**CCRFQ FS HVACELEC 25_1
DOWNSVIEW CAMPUS, SERVER ROOM 2220 UPGRADES
ADDENDUM #2**

M-01

Architect:	N/A	Date:	November 10th, 2025
Project:	UPS and Cooling Assessment at Downsview Campus	Project No.:	25-007

CENTENNIAL COLLEGE DOWNSVIEW CAMPUS IT ROOM UPGRADES

MECHANICAL SCHEDULES

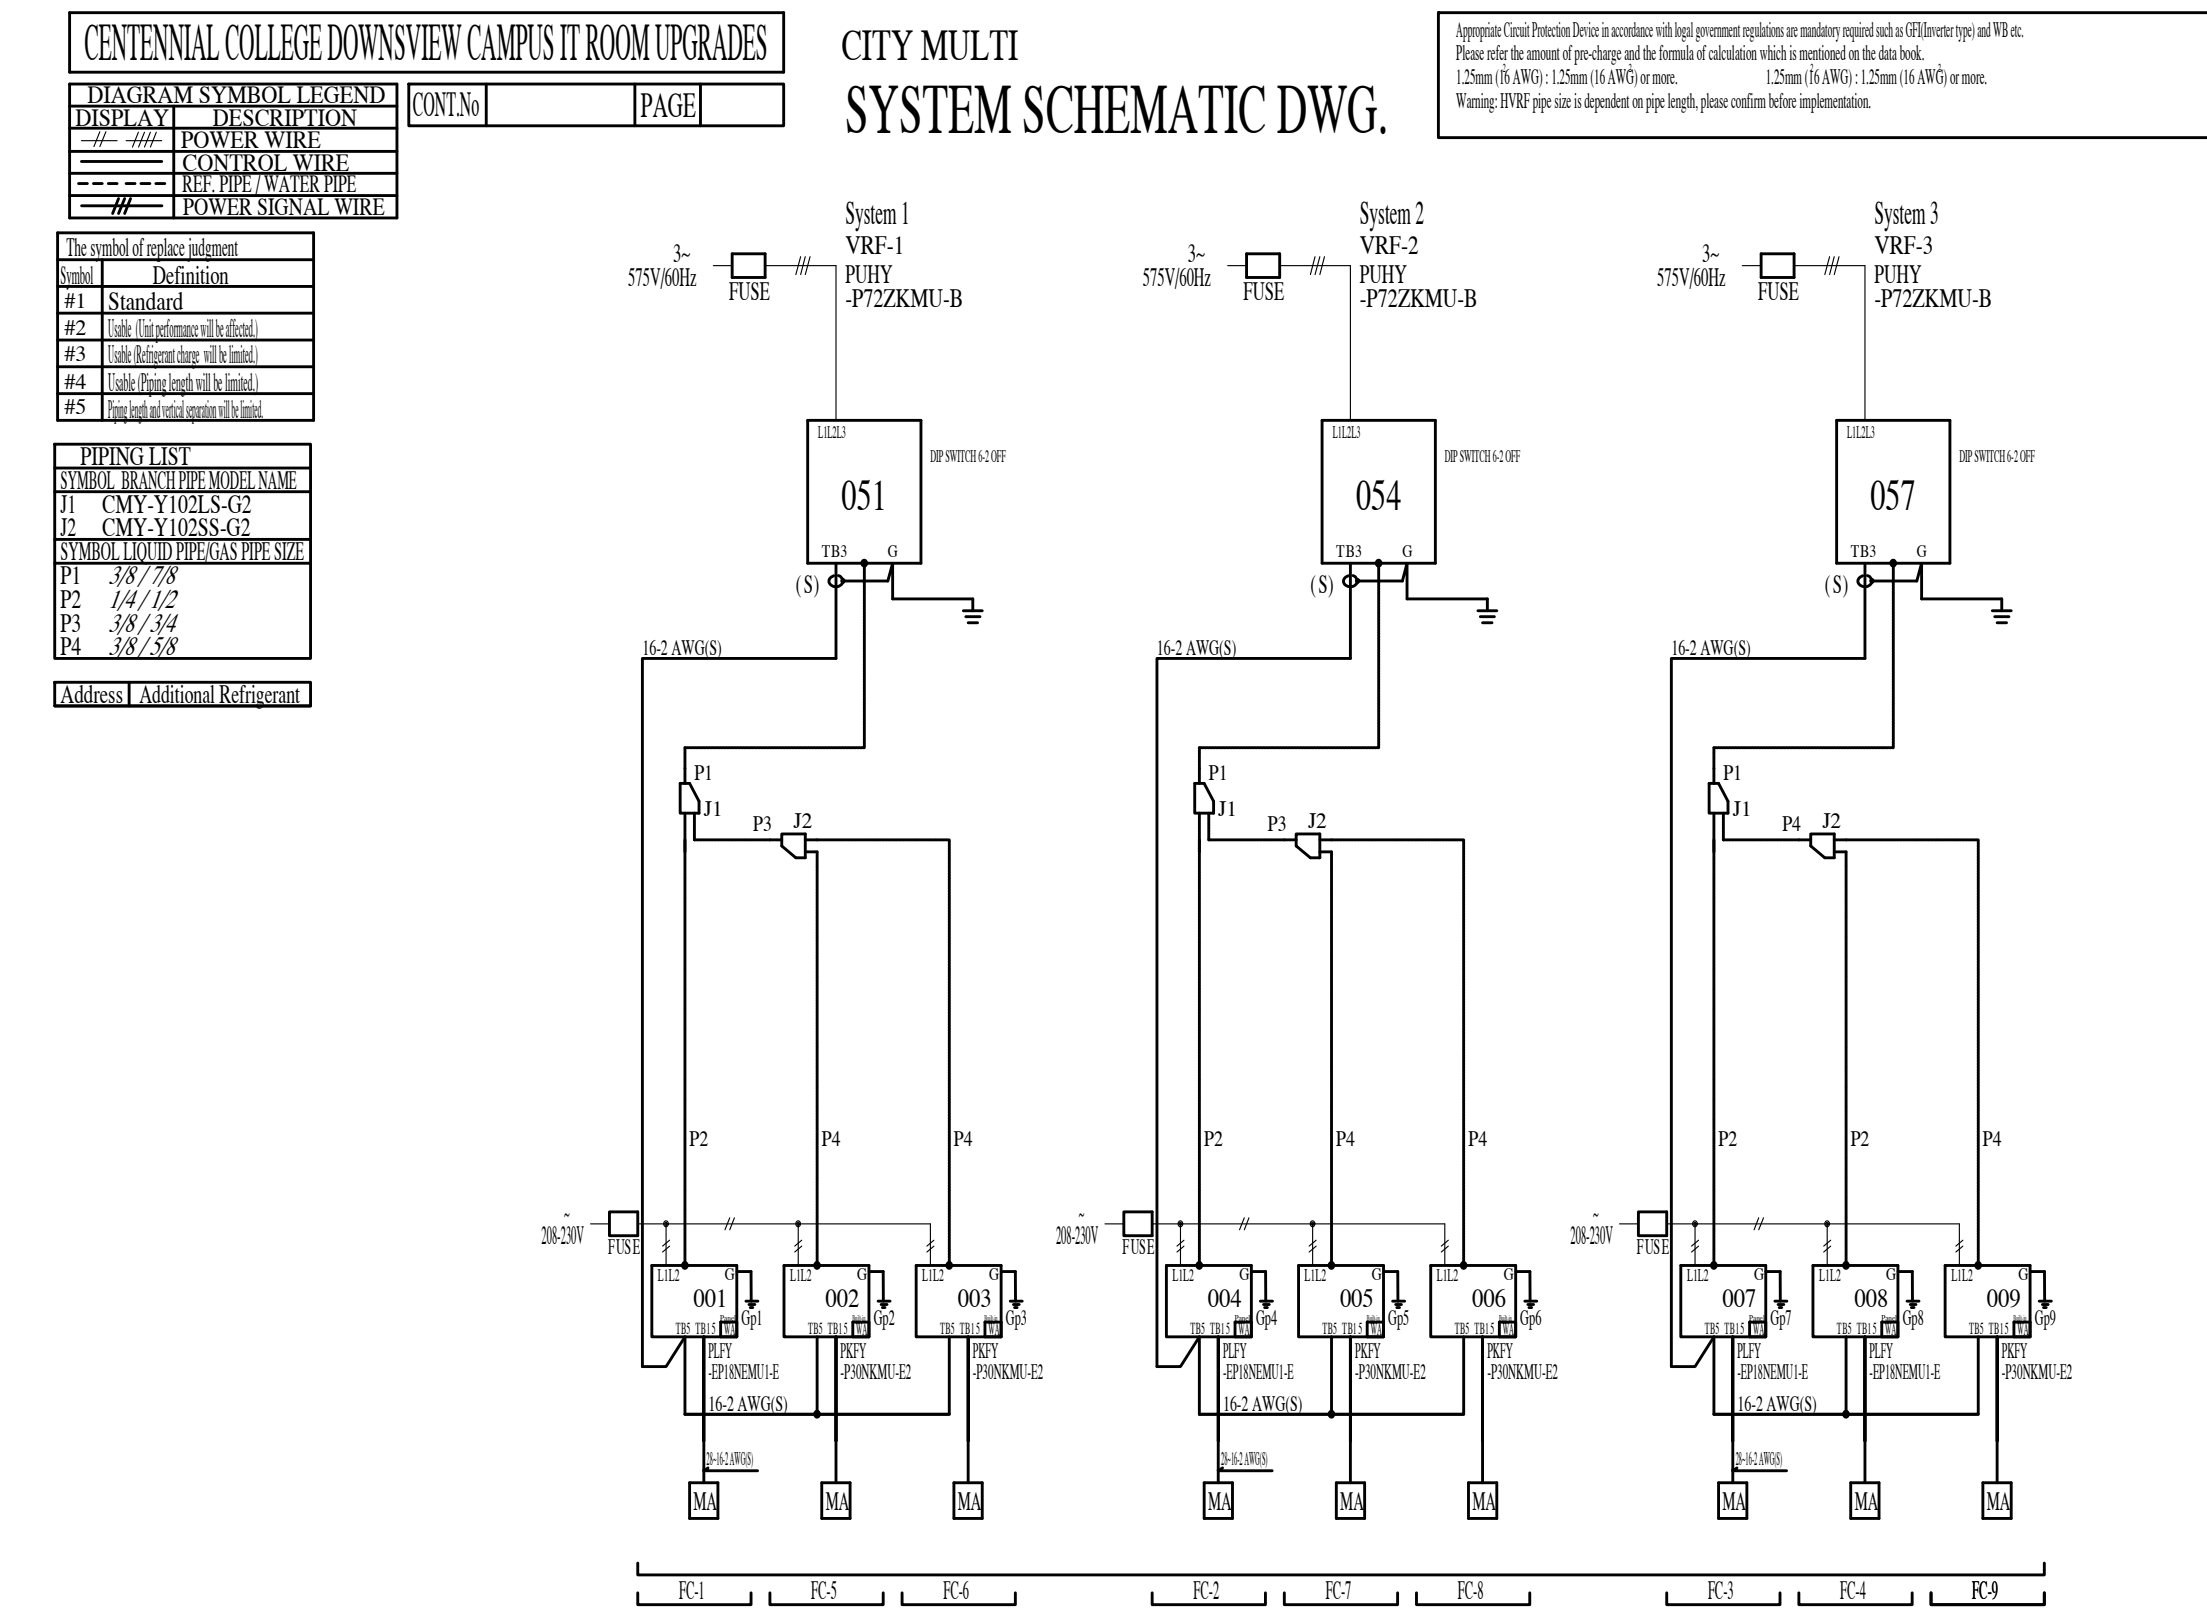
.1 Refer to Drawings M600

- Notes added to cooling unit's schedule: "C/W BACNET CARD CAPABLE OF STATUS INPUT TO BAS. COORDINATE WITH BASE BUILDING CONTROLS". To allow units to be controlled via independent thermostat control with existing in space humidity and temperature sensor tied back to the BAS to remain. Additional BAS input for equipment status of each new VRF unit is required

VRF FAN COIL UNIT SCHEDULE								
SYMBOL	LOCATION	MOUNTING	TOTAL COOLING (KW)	TOTAL HEATING (KW)	VOLTAGE/PH/Hz	MCA	WEIGHT (KG)	MANUFACTURER AND MODEL (BASIS OF DESIGN: MITSUBISHI AIR)
FC-1 TO FC-4	IT ROOM - 2220	CEILING	5.3	N/A	208, 1- Phase, 60 Hz	0.54	25	MITSUBISHI ELECTRIC: PLY-EP18NEMU-E1R1-T C/W CONDENSATE PUMP, WIRED TO NEW COMMON THERMOSTAT; C/W BACNET CARD, CAPABLE OF STATUS INPUT TO BAS. COORDINATE WITH BASE BUILDING CONTROLS
FC-5 TO FC-9	IT ROOM - 2220	WALL	8.8	N/A	208, 1- Phase, 60 Hz	0.63	21

VRF OUTDOOR UNIT SCHEDULE								
SYMBOL	LOCATION	TOTAL COOLING (KW)	TOTAL HEATING (KW)	VOLTAGE/PH/Hz	MCA	MOCP	WEIGHT (KG)	MANUFACTURER AND MODEL (BASIS OF DESIGN: MITSUBISHI AIR)
VRF-1 TO VRF-3	ROOF	21.1	N/A	575V, 3- Phase, 60 Hz	11	15	222	MITSUBISHI ELECTRIC: PUHY-P72ZKMU-B (-BS) C/W LOW AMBIENT COOLING KIT: HOOD WITH CONTROL DAMPER ASSEMBLY & WIND DEFLECTORS, C/W BACNET CARD CAPABLE OF STATUS INPUT TO BAS. COORDINATE WITH BASE BUILDING CONTROLS
